# HISTORIC AND DESIGN REVIEW COMMISSION

October 05, 2016

**HDRC CASE NO:** 2016-363  
**COMMON NAME:** Malt House  
**ADDRESS:** 115 S ZARZAMORA  
**LEGAL DESCRIPTION:** NCB 2322 BLK 1 LOT 7&8 AND 9  
**ZONING:** C-2 HL  
**CITY COUNCIL DIST.:** 5  
**LANDMARK:** Malt House Restaurant  
**APPLICANT:** 7-Eleven, Inc.  
**OWNER:** Baldemar Gonzalez  
**TYPE OF WORK:** Demolition with New Construction  
**REQUEST:**

The applicant is requesting a conceptual approval to:

7-ELEVEN, INC.  
3200 HACKBERRY RD. IRVING, TX 75063  
7-11 #1037932  
115 S. ZARZAMORA ST.  
SAN ANTONIO, TX 78207  
EXTERIOR ELEVATIONS

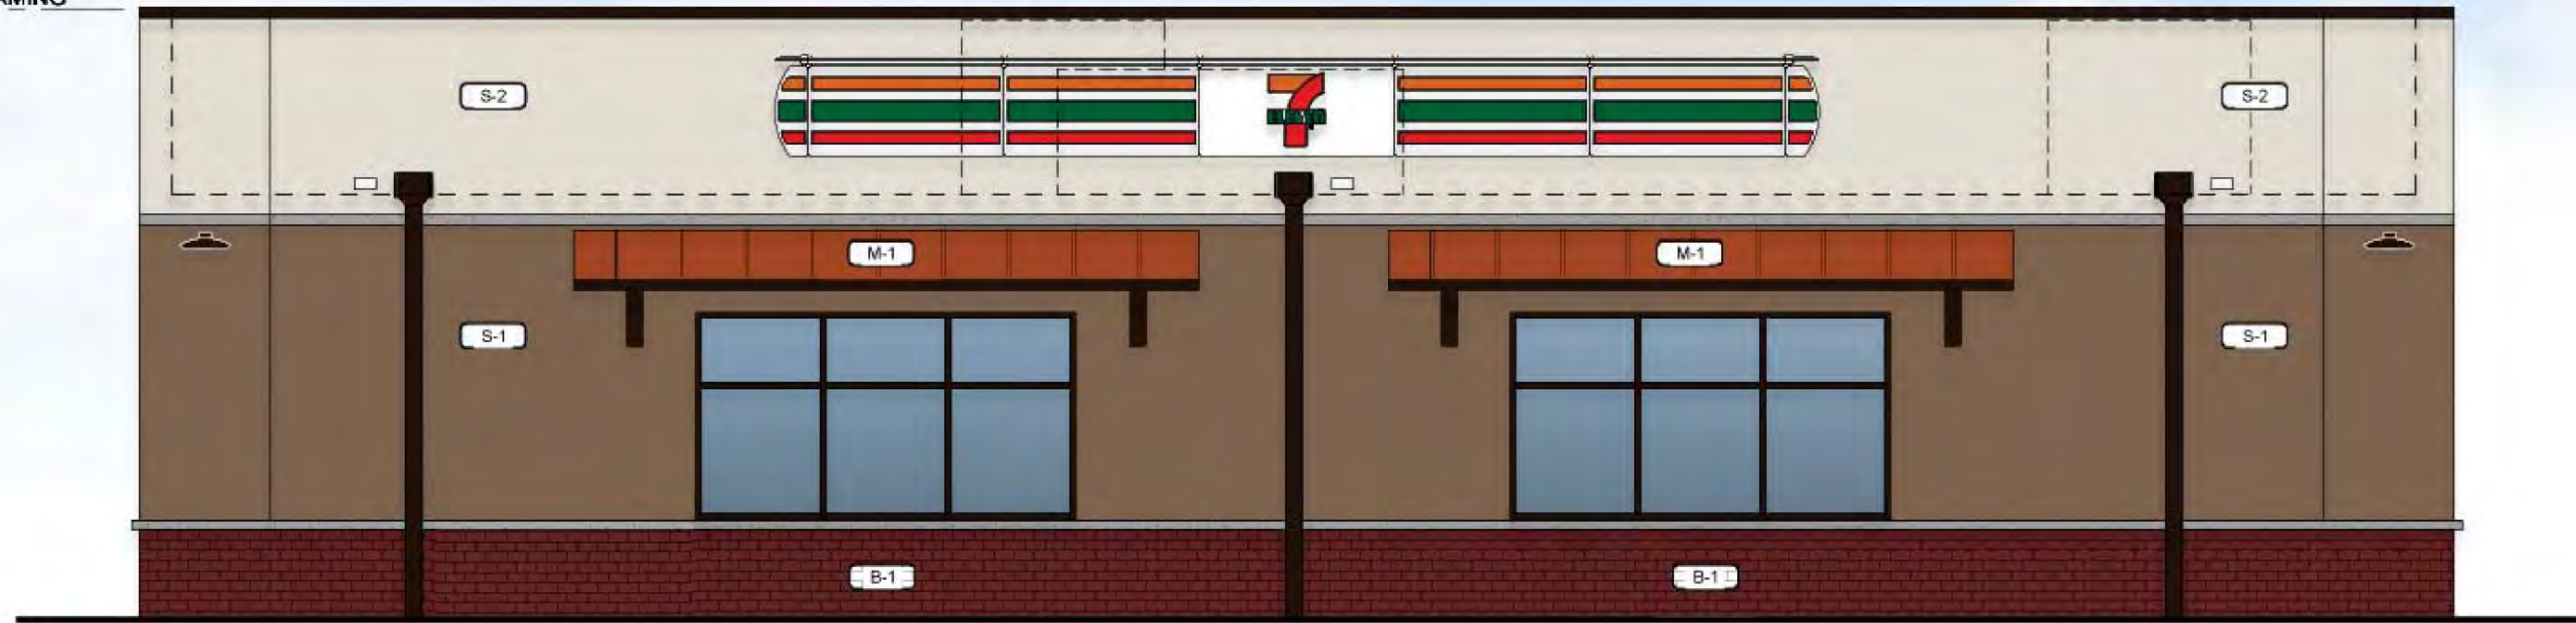
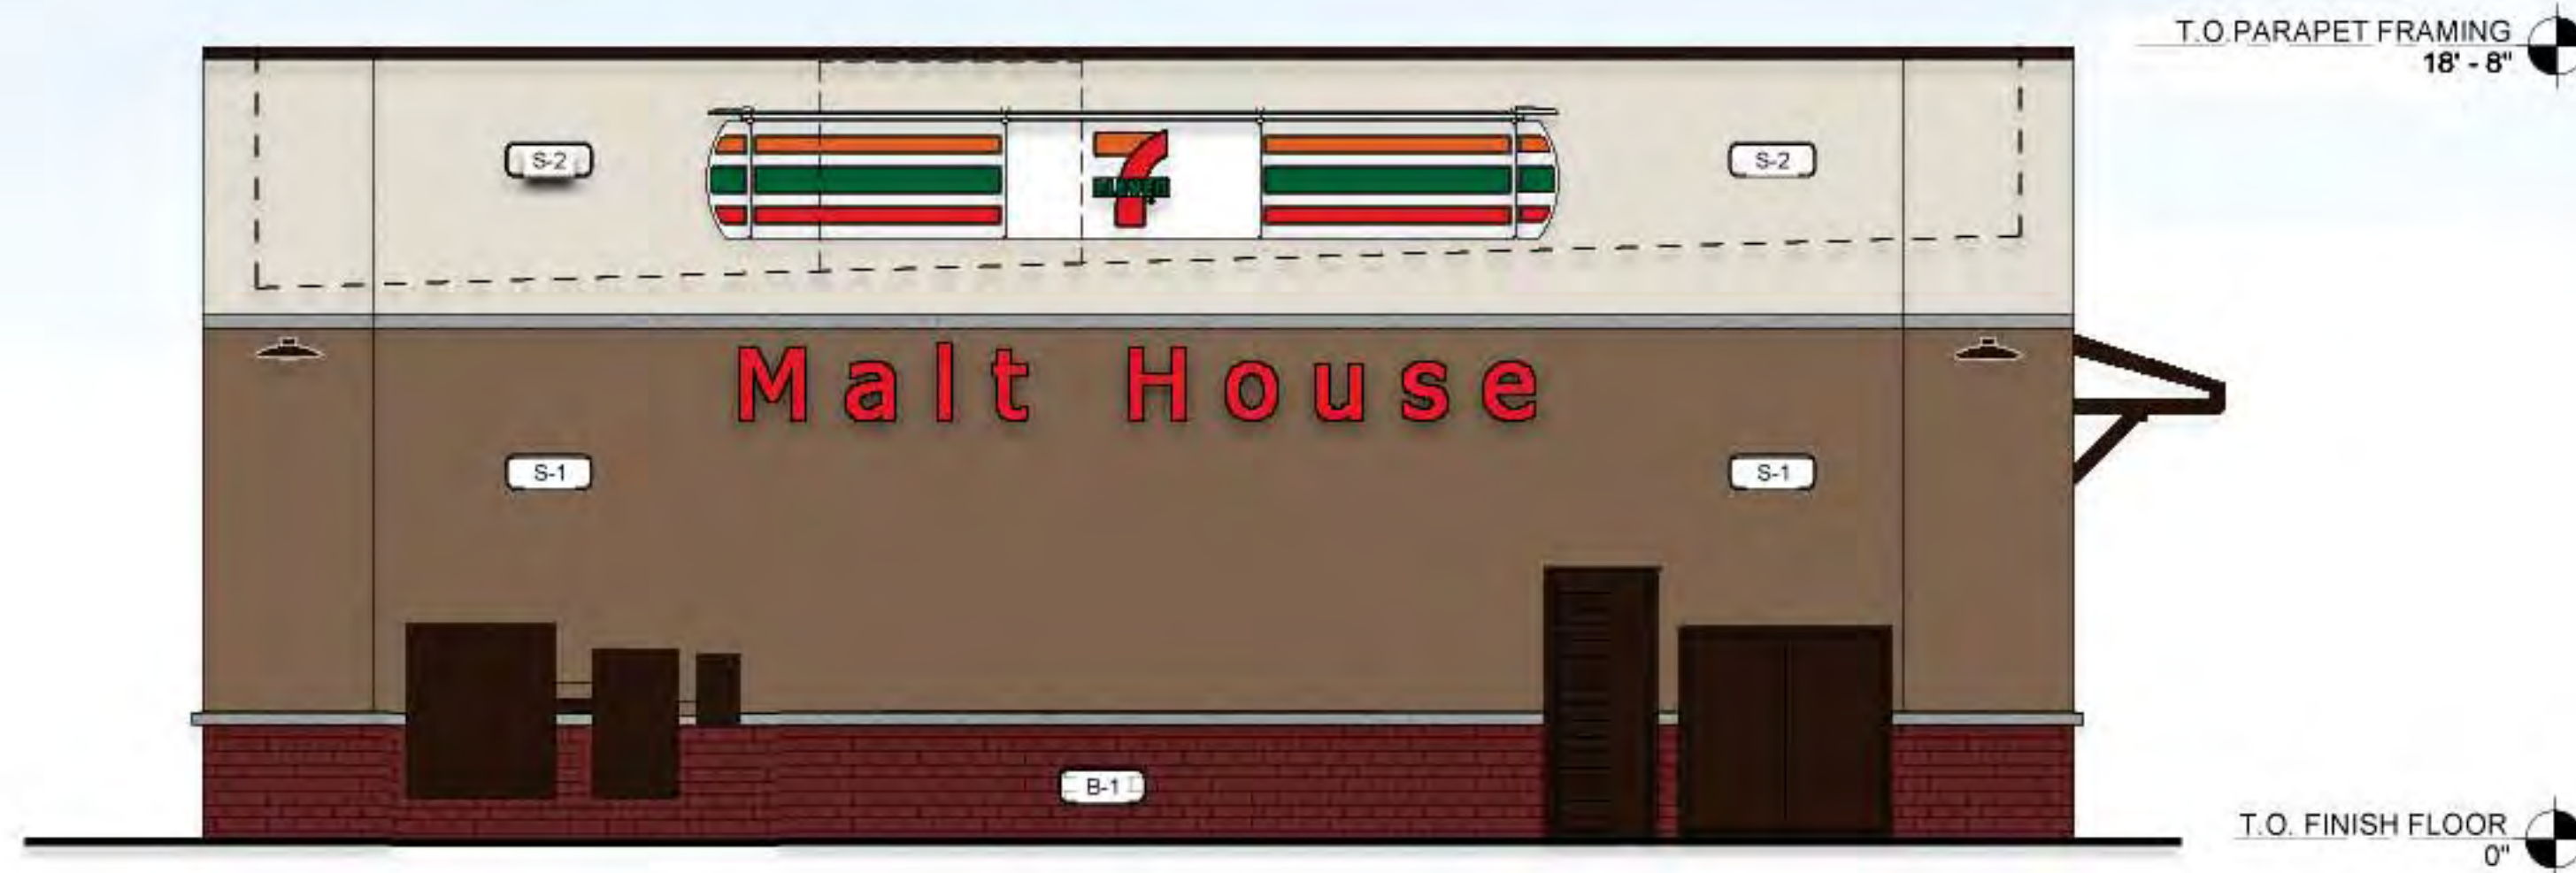
MG: Questions about <sup>existing Malt</sup> south elevation and if ~~#~~ proposed

corresponds or nods to existing. Questions about existing window signs.

TC: Questions on if can switch elevation as Zanzamora elevation acts as front to pedestrian.

MG: Questions about sign.

Applicant suggests wall mount w/ smaller  
version of sign on North; remove neon tubing.  
Increase height on wall to 8'

**LANDSCAPE PLAN**

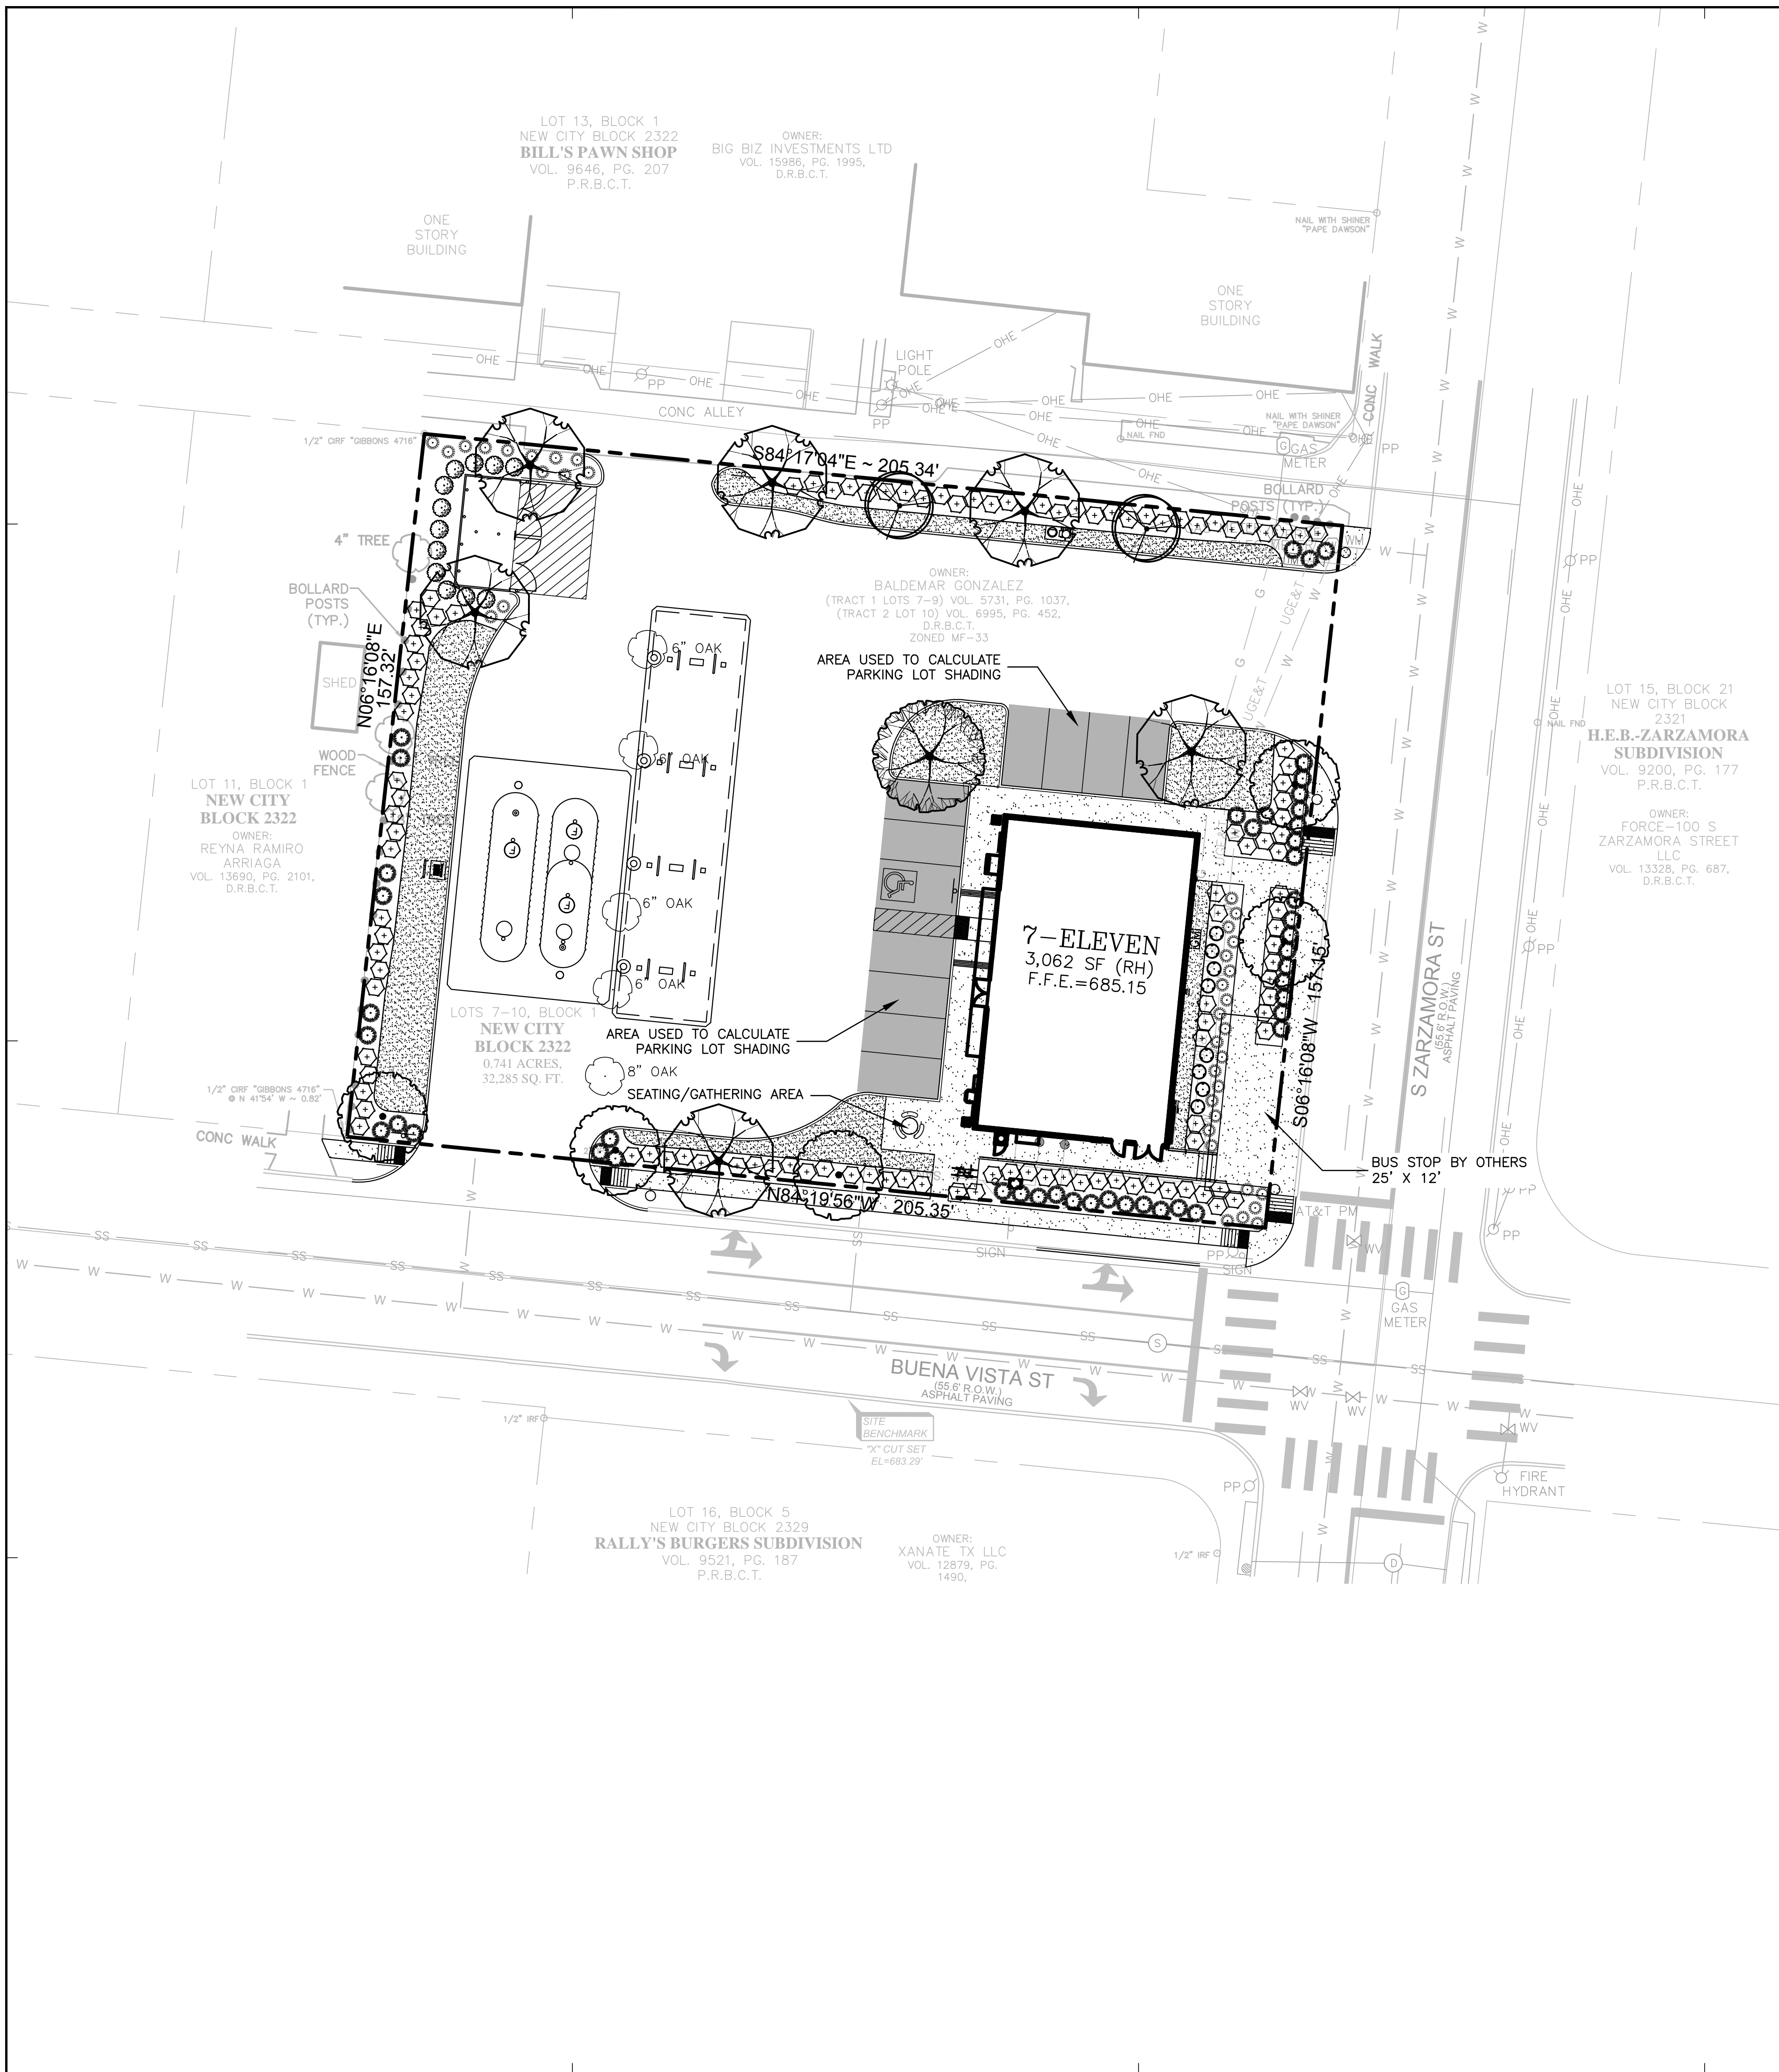
- t. SITE ELEMENTS – The existing site is paved with asphalt except for two planting strips with grass. The applicant is proposing a paved site with landscaping consisting of Bermuda grass, and various trees and shrubs along the west property line, north property line, and street frontages. According to the Guidelines for Site Elements 3, a varied plant palette with varied heights and native plant materials should be used; impervious surfaces should not be introduced where not historically located. Staff finds the proposed paving and landscaping consistent with the Guidelines.

MG: Questions about proposed landscaping + possible screening.
